Addendum No.: 6

Date Of Addendum: September 28, 2017

**Fire Alarm & Sprinkler Project  
Veterans' Home – 287 West Street  
Rocky Hill, CT  
BI – C – 285 / FAI Number 09-016**

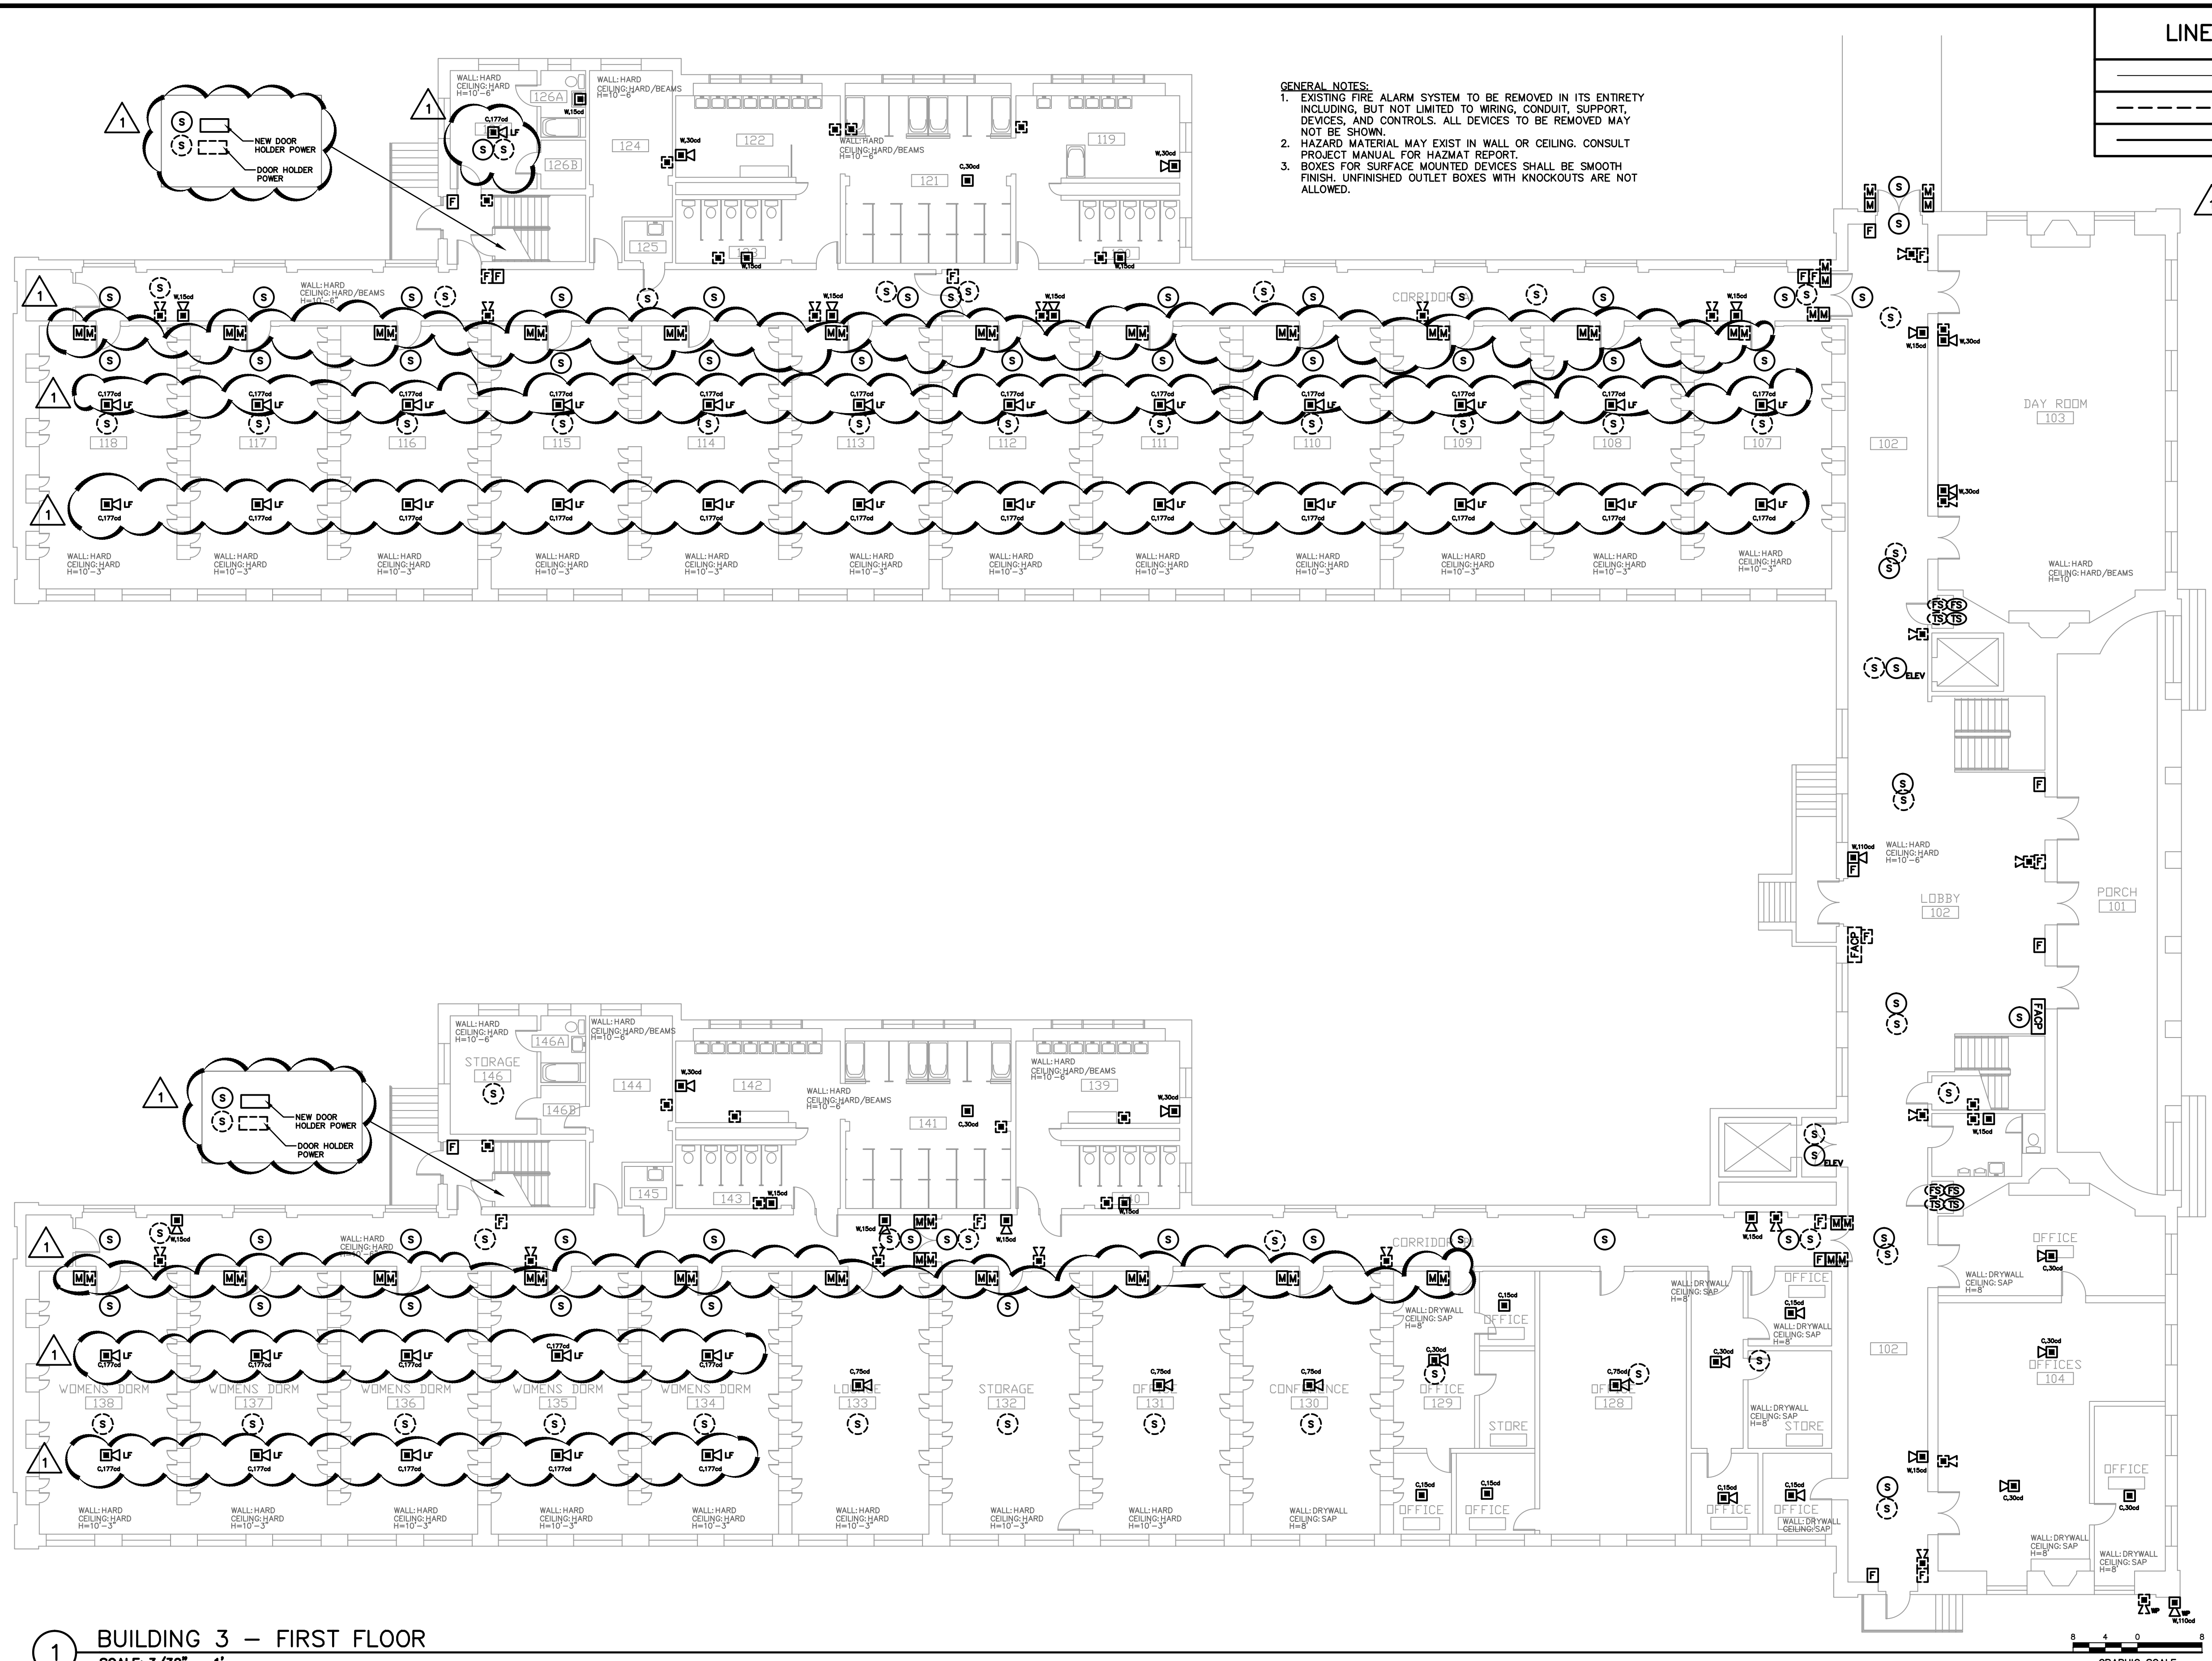
Building's #3, #4, #50, #52 - Horn/strobes within sleeping areas shall have low frequency sounder. See revised drawings FA103.1, FA103.2, FA104.1, FA104.2, FA150.0, FA150.1, FA150.2, FA150.3, and FA152.0. Low frequency sounders shall meet the requirements of NFPA 72 – 2010 18.4.5.3.

Building's #3, #4 - New magnet door holders to the sleeping rooms shall be provided. See revised drawings FA103.1, FA103.2, FA104.1 and FA104.2. Contractor shall use existing 120 volt power noted on drawings for door holders if needed.

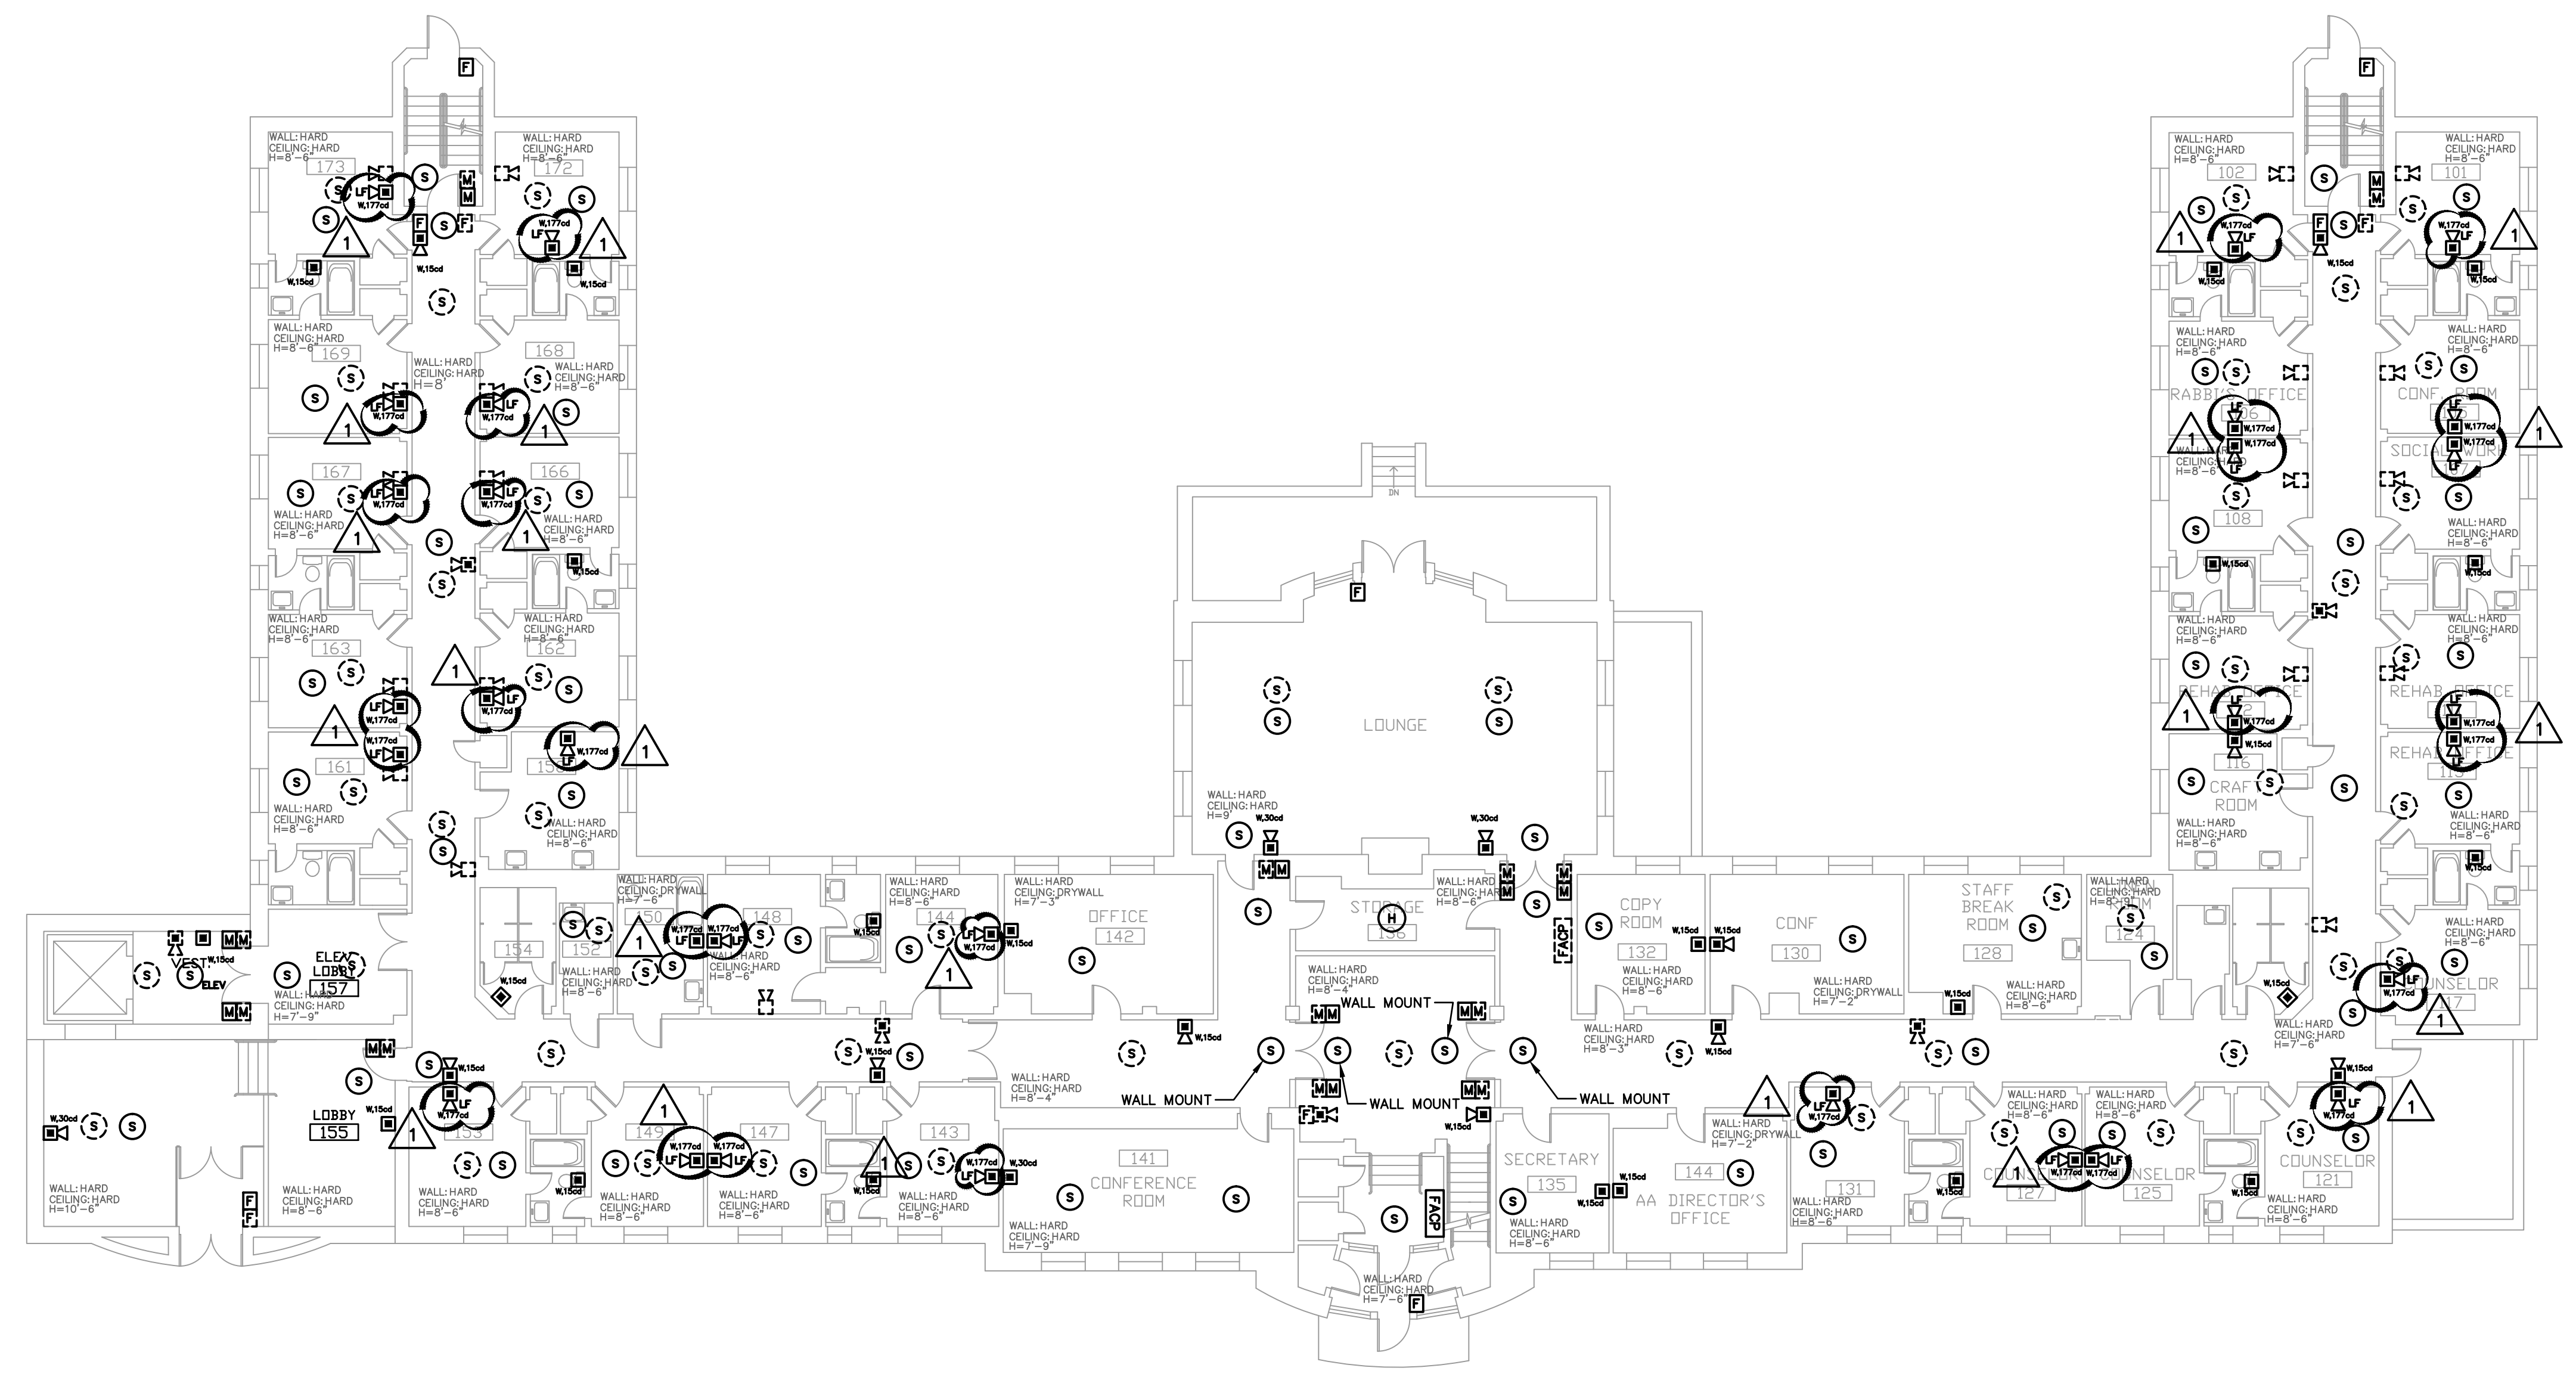
Building #50 – First Floor – Provide weatherproof exterior horn/strobe adjacent to front door on outside wall of conference room.

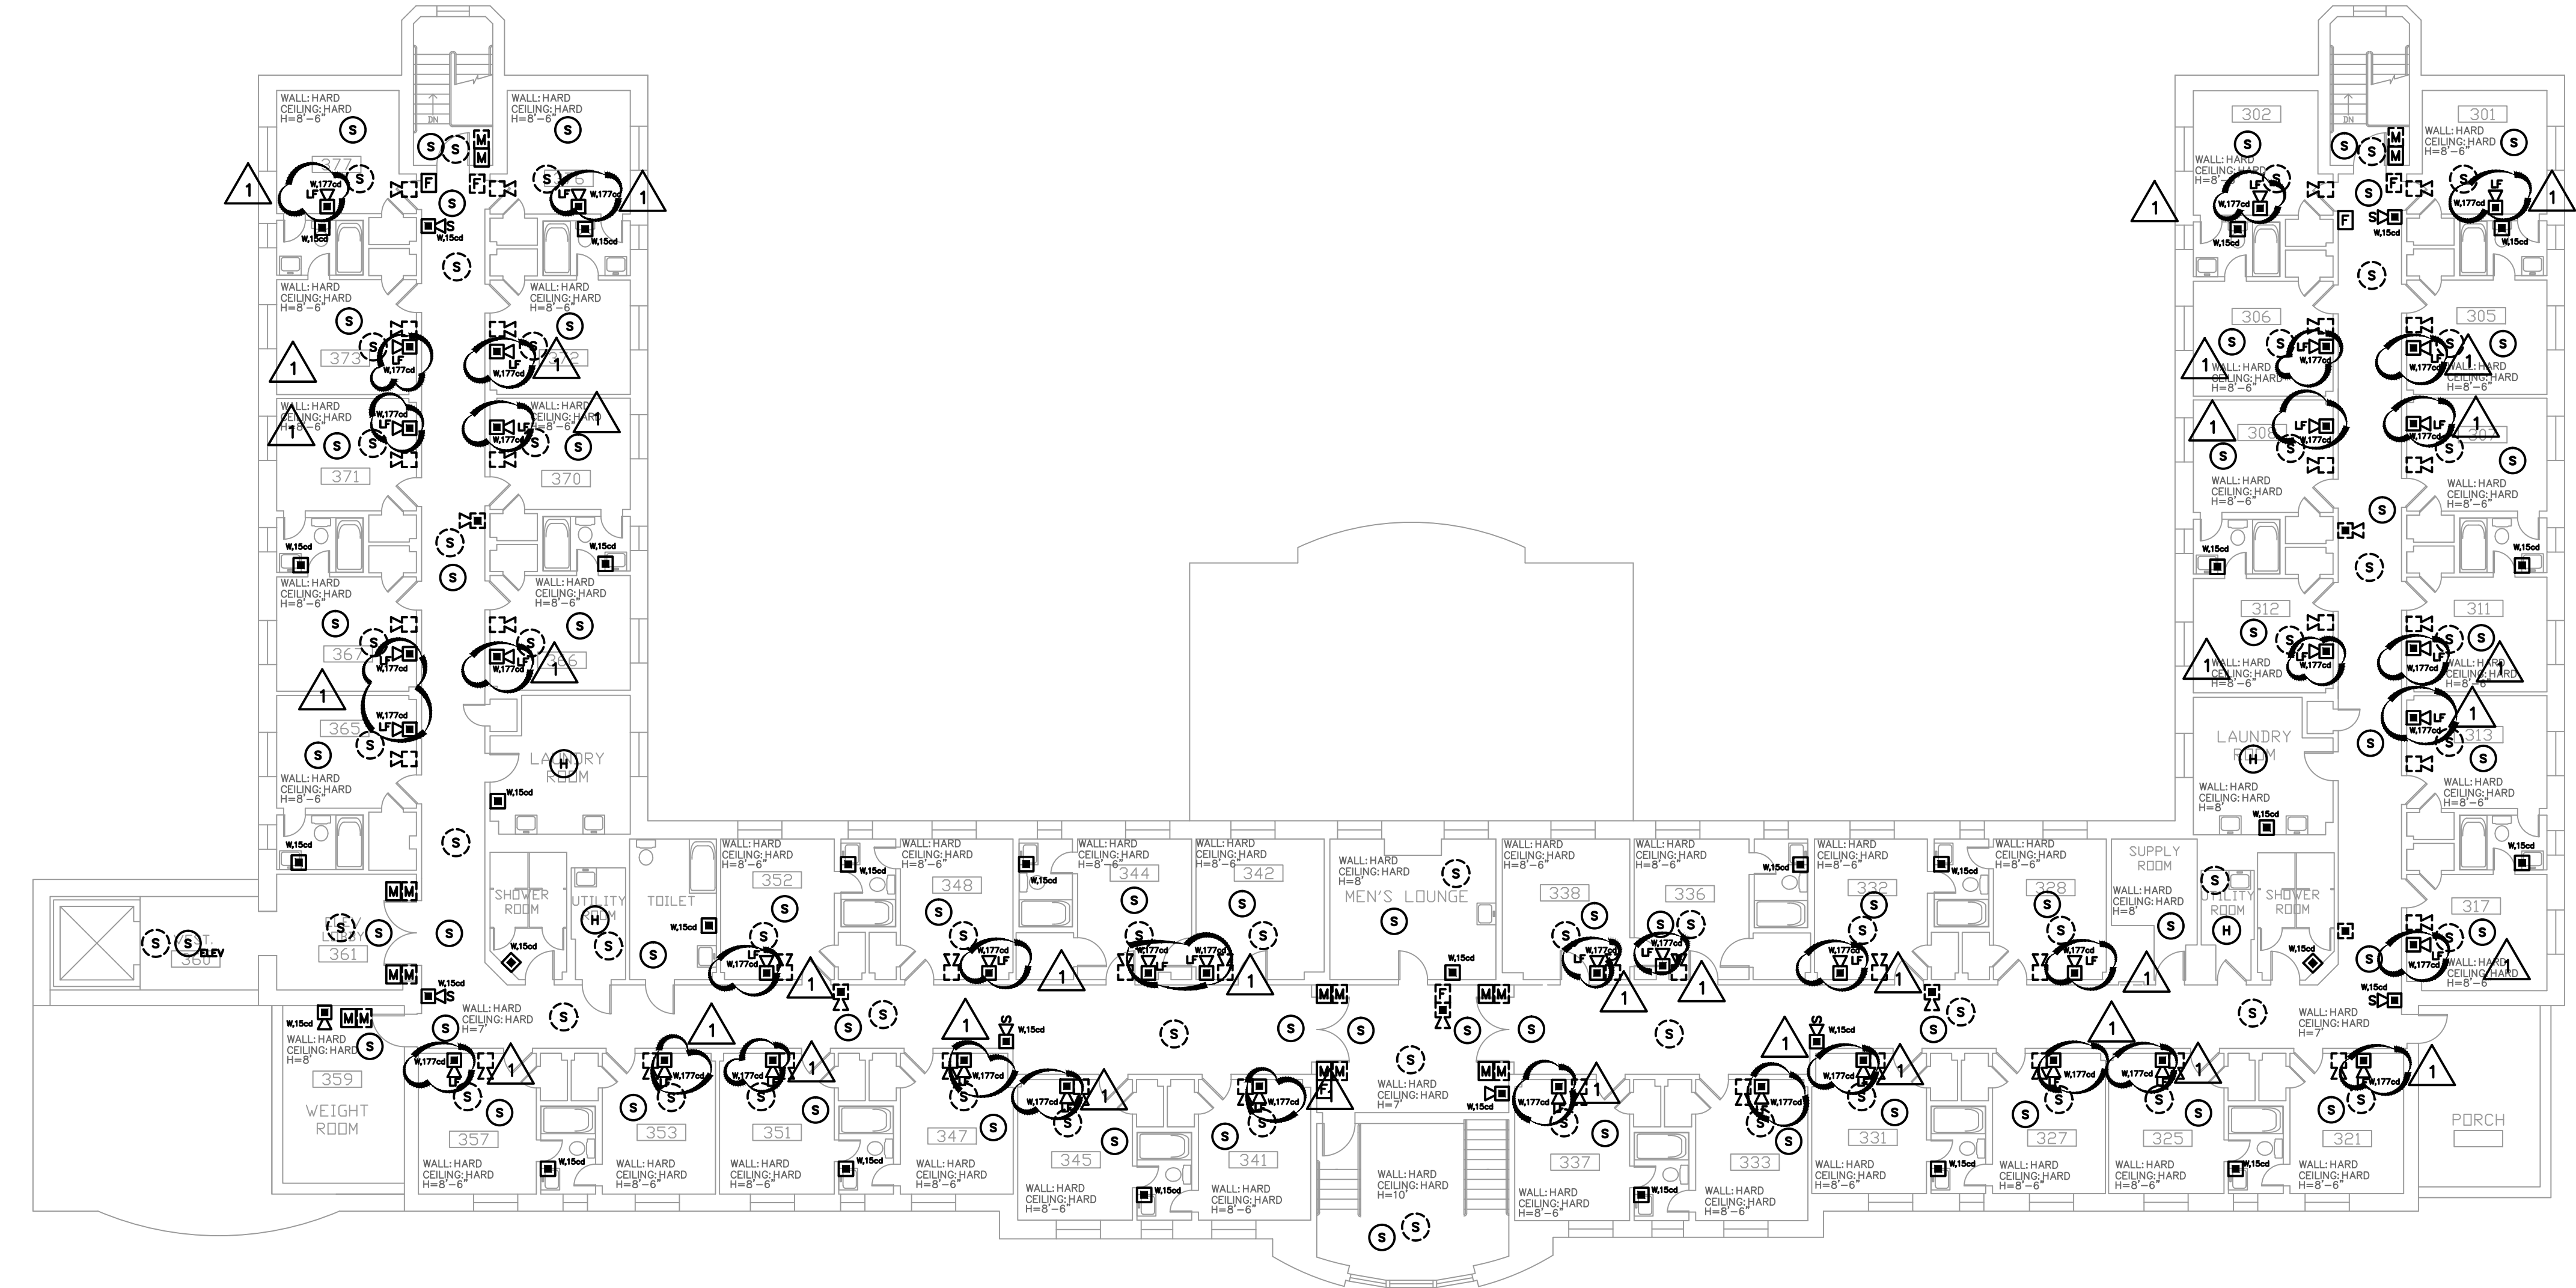
Building #50 – Third Floor – Speaker/strobes shown shall be Horn/strobes.
